Comments on the CanWhite Sand Vivian Extraction Project
By
D.M. LeNeveu B.Sc (hons. physics), M.Sc. (biophysics). B.Ed.
On Behalf of What the Frack Manitoba
Oct. 5, 2021

On Aug. 3, 2021 CanWhite Sands submitted two documents to the Manitoba public registry file # 6119.00 to support CanWhite Sands Corporation (CWS) Silica Sand Extraction Project. The documents are an Environment Act Proposal for the Vivian Sand Extraction Project (EAP) and the Vivian Sand Extraction Project – Hydrogeology and Geochemistry Assessment Report (HGR). The authors of the Extraction EAP are Marlene Gifford, M.Sc. P. Bio, Biologist, Environmental Assessor and Clifton Samoiloff, B. Sc. EP(CEA), Mining Market Sector Lead, Canada. These were the same two authors who prepared the EAP for the CWS Vivian Sands Processing Plant for AECOM Ltd. The contributors to the HGR prepared by AECOM Ltd. include Reuben Dandurand, M.Sc., G.I.T. (BC), Stephen Dickin, P.Geo. (MB, BC) Senior Hydrogeologist / Groundwater Modeller, Kun Jia, M.Sc., P.Geo. (BC) Geochemist/Hydrogeologist, Mehrnoush Javadi, M.Sc., Ph.D. Geochemist/Hydrogeologis, Chris Donnelly, M.Sc., P.Geo. (BC, AB), and Ryan Mills, M.Sc., P.Geo. (MB, BC, AB) Senior

Figure 3. Limestone thickness in the CWS project area taken from drilling reports supplied by Manitoba Groundwater for CWS wells

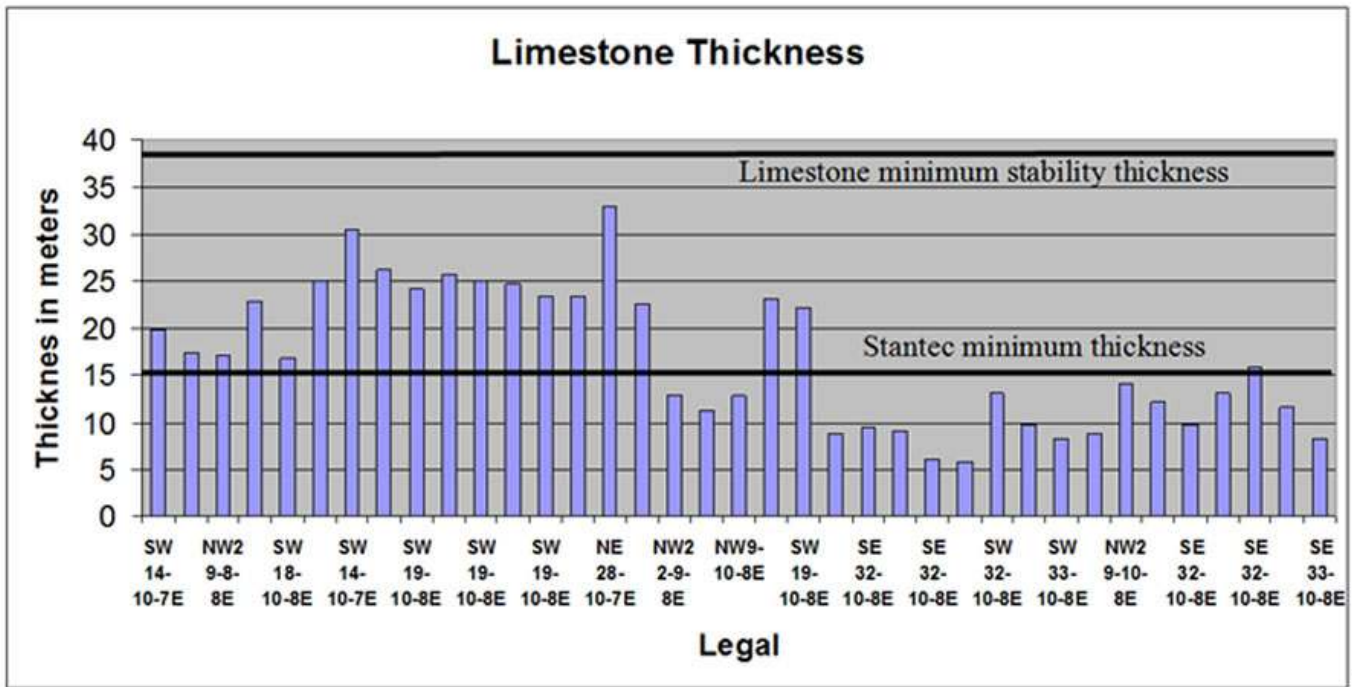
The core log for Bru 95-8 in the HGR report gives the limestone from 32.3 to 35.3 meter depth below surface to be weathered and incompetent. Thus there are 3 meters of incompetent limestone documented. This is followed by 1.6 meters of competent limestone to a depth of 36.9 meters. Next are 1.5 meters of limestone with small vugs which are small cavities. Limestone with vugs would not be competent. Next is a clay rich layer of 1.5 meters to a depth of 39.9 meters, followed by a 1.5 meters limestone with horizontal fractures to a depth of 41.4 meters. The clay layer and the limestone layer with horizontal fractures would not be competent. A final limestone layer 4.6 meters thick to 46 meters depth is reported with no comment as to integrity. In the column of limestone for Bru 95-8 there are at most only 6.2 meters of competent limestone out of the 13.7 meters. The Bru 95-8 core log is hard evidence supplied by CWS itself that the limestone in the Bru area is not competent or strong.

The full depth of the limestone for well Bru 95-8 at 13.7 meters is less than the Stantec limit of 15 meters. Figure 1 of the questions document illustrates that none of 37 drill reports give limestone thickness in the Bru area over 37.8 meters. In the eastern area where extraction would begin, most limestone thicknesses are less than the unverified Stantec limit of 15 meters. The figure of limestone thickness from the questions document is repeated here as figure 3.

Figure 4. Land Subsidence from CWS well clusters and subsequent aquifer damage and contamination from surface runoff and drainage.

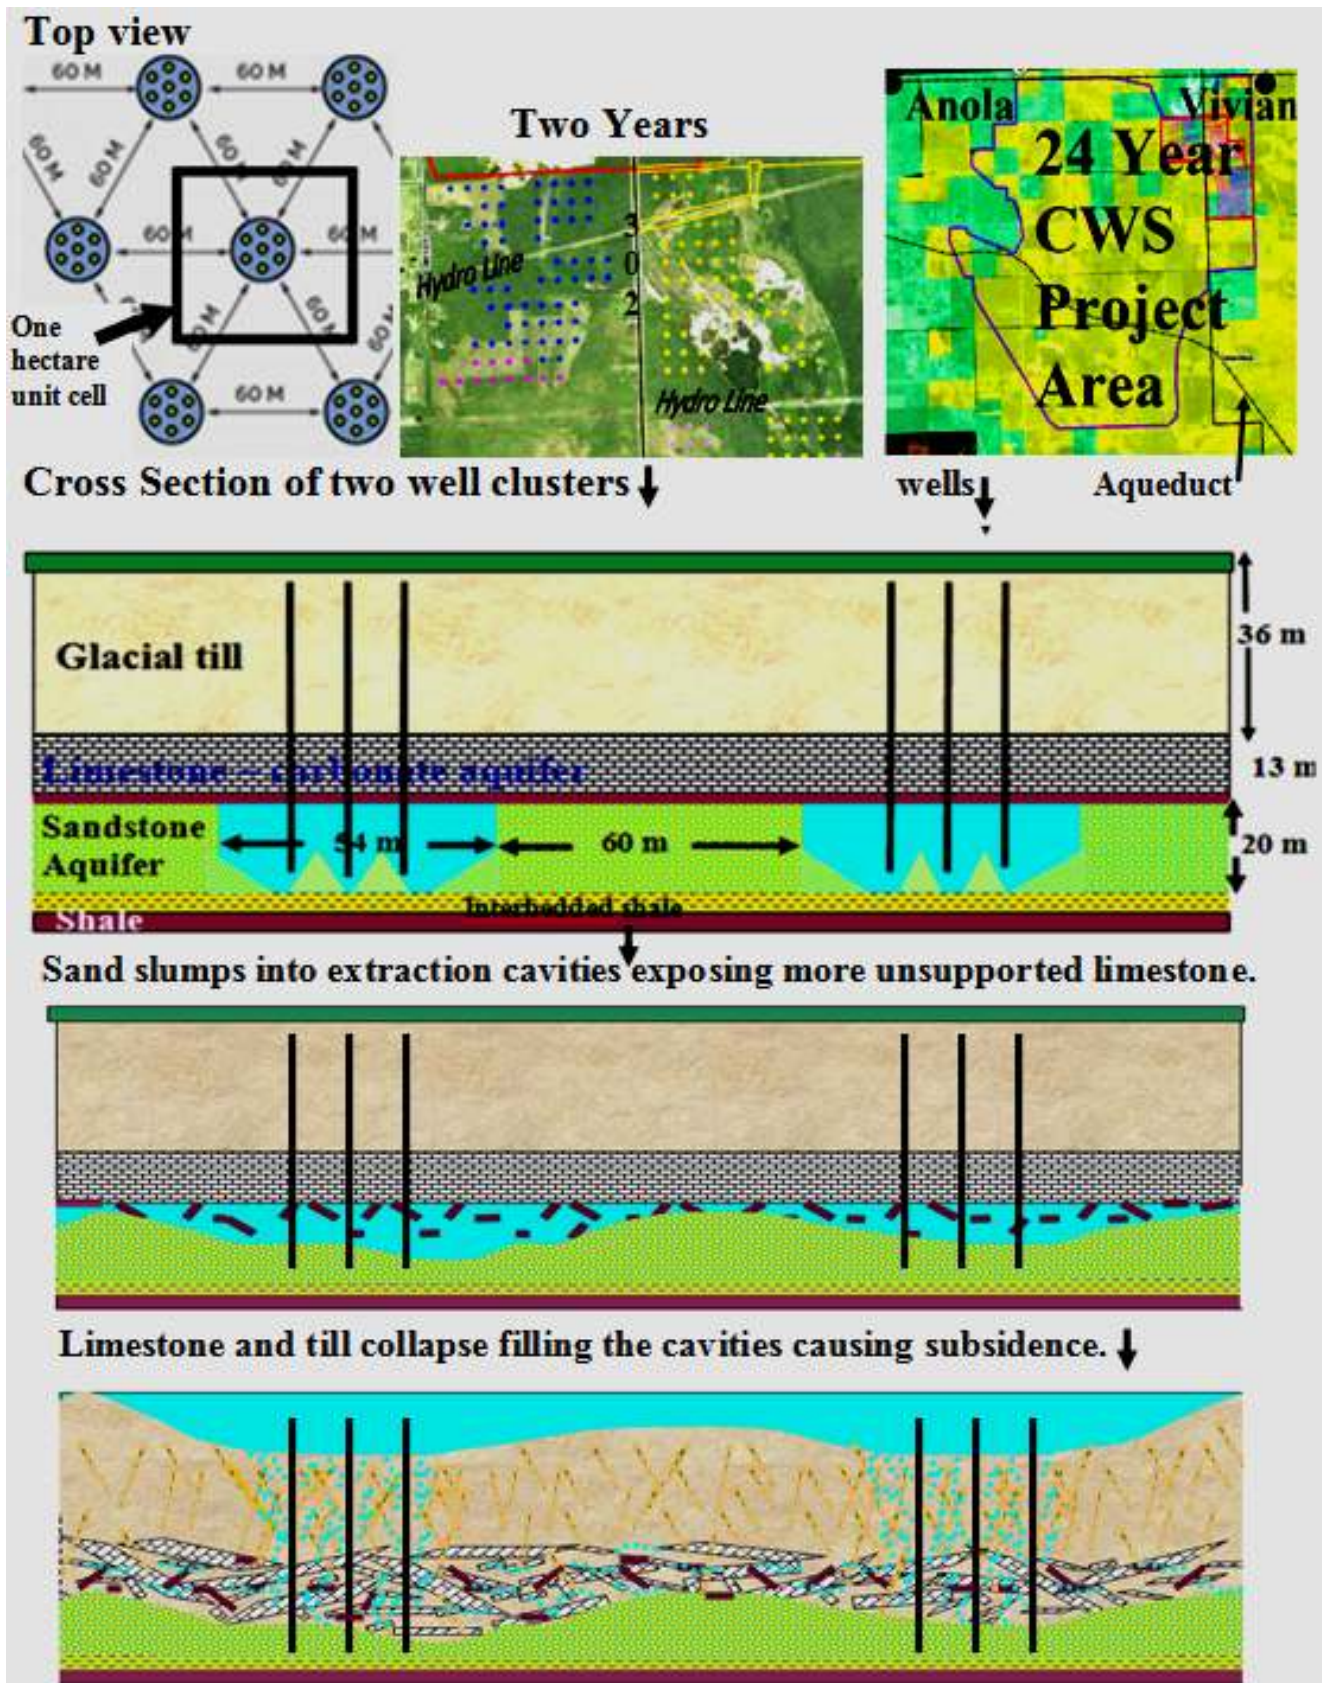
Sand slumping would enlarge the cavities under the well clusters creating an ever more unstable situation. Figure 4 illustrates the geometry of the well clusters and a unit cell within the clusters.

Figure 4 illustrates the progressive slumping of sand pillars into the excavation cavities and the subsequent collapse of the limestone layer. The subsidence and collapse would open the remaining carbonate aquifer to contamination from surface water runoff.

The unit cell in figure 4 is 114 meters wide by 98.7 meters high covering 1.12 hectares with a central cavity of 54 meters in diameter. The extraction EAP states that a cone of sand would be extracted around each well and that the wells in each well cluster are separated by 18 meters. According to the extraction EAP 3,000 tonnes of sand are to be extracted from each well in a well cluster. The actual volume of material extracted from each cluster would be greater due to the waste in terms of concretions and other over sized particles that are screened out at the extraction site.

The extraction cones around each well would overlap such that the entire 54 meter diameter well cluster would be open at the top. The extraction ratio for the cavity for the unit cell shown in figure 4 would be 0.203 (~20%). The unit cell and the 20% extraction ratio in the sand layer repeats as the well clusters expand. The extraction ratio quoted in the EAP for the processing plant of 5% would include the layers of limestone and glacial till above the sand layer thus giving a much smaller extraction ratio.

Figure 8. Planned location of CWS well clusters up to 2025 from the CWS HGR

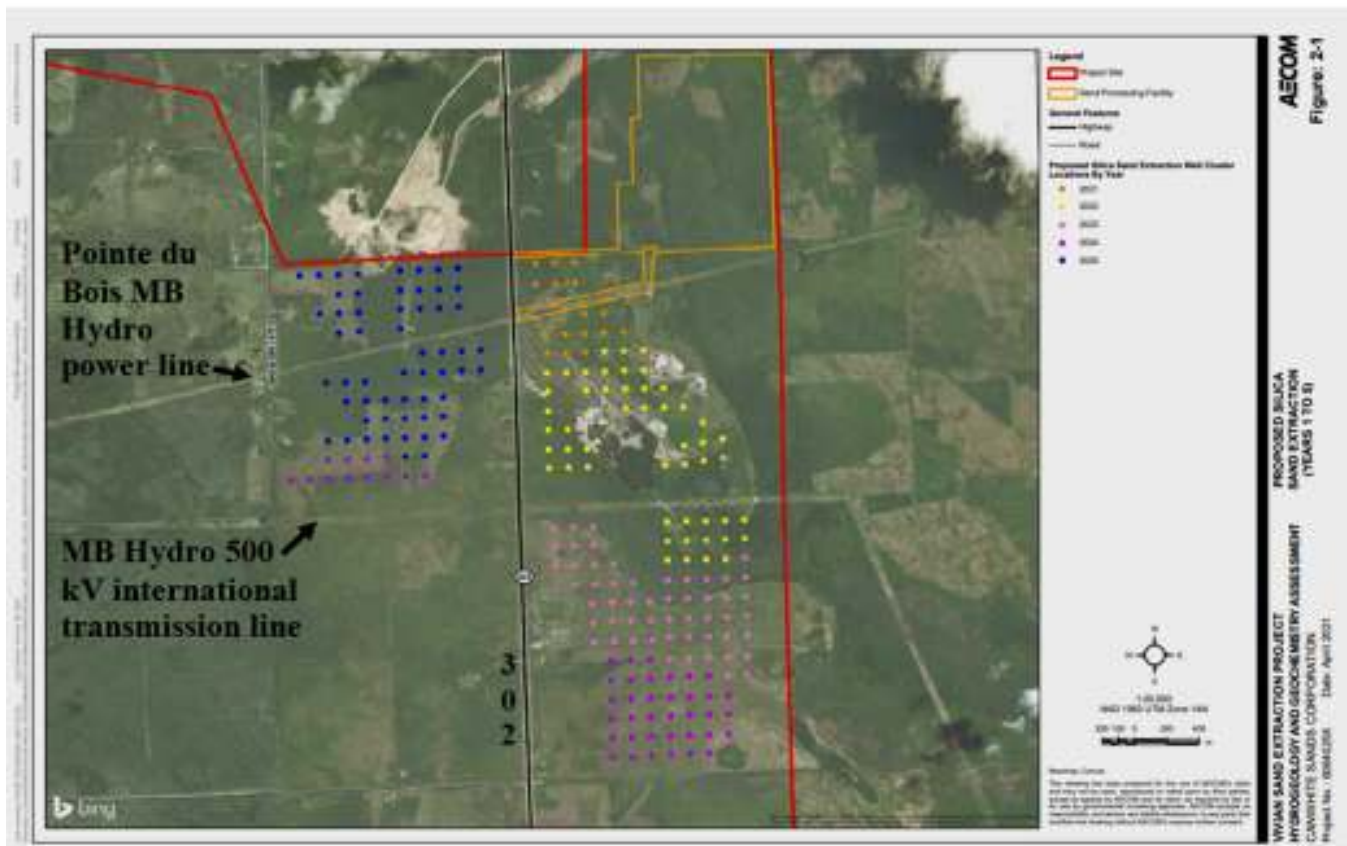
As shown in figure 8 the CWS well clusters up until 2025 would be on either side of the provincial highway 302. CWS slurry lines and heavy equipment such as vacuum trucks and drill rigs would be required to cross highway 302. To our knowledge CWS has not notified Manitoba Infrastructure nor obtained permission for the disturbance to highway 302. The land subsidence that could occur from the well clusters could destabilize the road bed and would affect road drainage. CWS should have identified these engineering issues and documented the risks and planned mitigation.

Figure 9. Location of MB Hydro Pointe du Bois power line, the MB Hydro 500 kV international transmission line, Winnipeg aqueduct and CN mainline.³⁷ The CWS project boundary is shown by the purple line

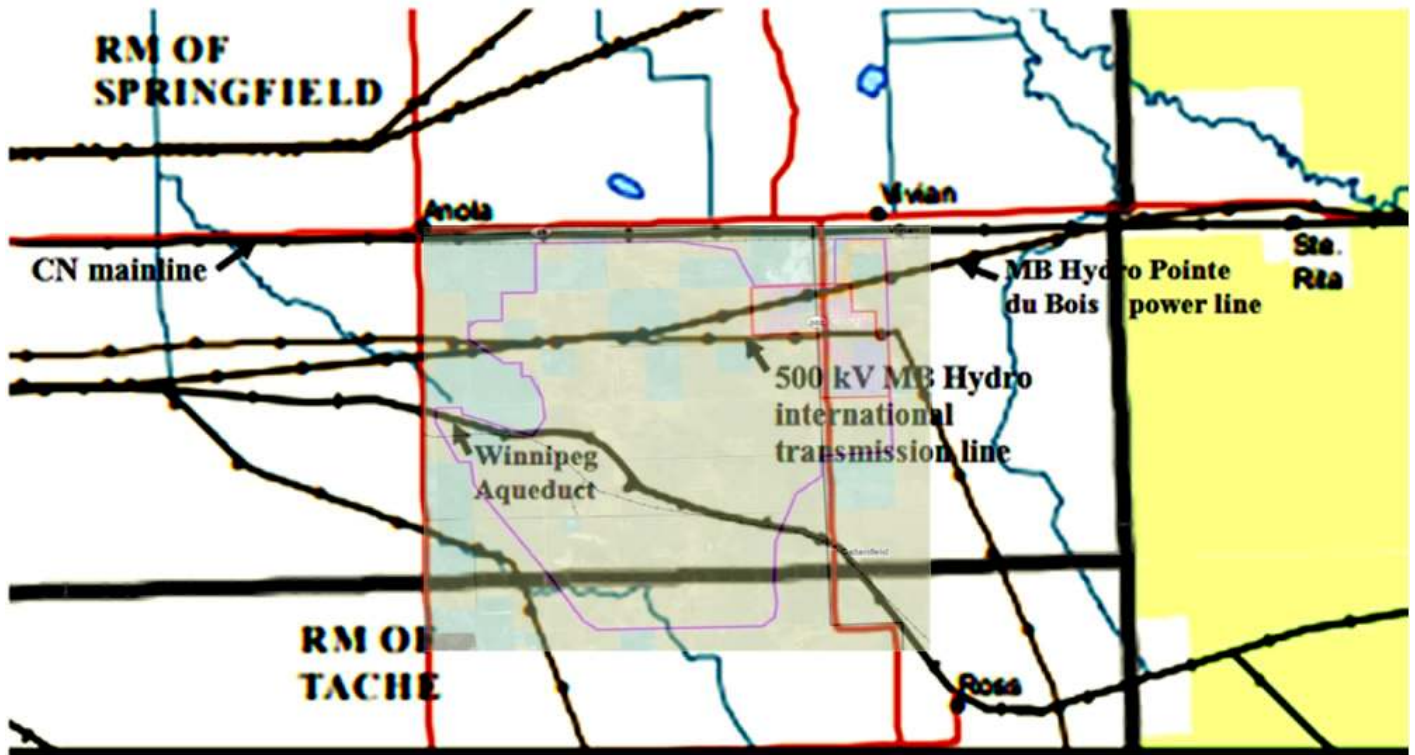
The location of the MB Hydro Pointe du Bois power line and the 500 kV International Transmission Line to Minnesota as well as the Winnipeg aqueduct and the CN mainline railway are shown in figure 9.

Fourteen and six inch diameter HDPE slurry lines that would carry the extracted sand to the Vivian Sand Processing Plant and recycled return water lines would cross the Hydro lines multiple times. The six inch sand slurry HDPE lines would be emptied into vacuum trucks and moved every five to seven days each time crossing the hydro lines anew when extraction is in that vicinity. The fourteen inch main slurry line and the return recycle water lines would have to be moved, crossing the hydro lines repeatedly in different locations.
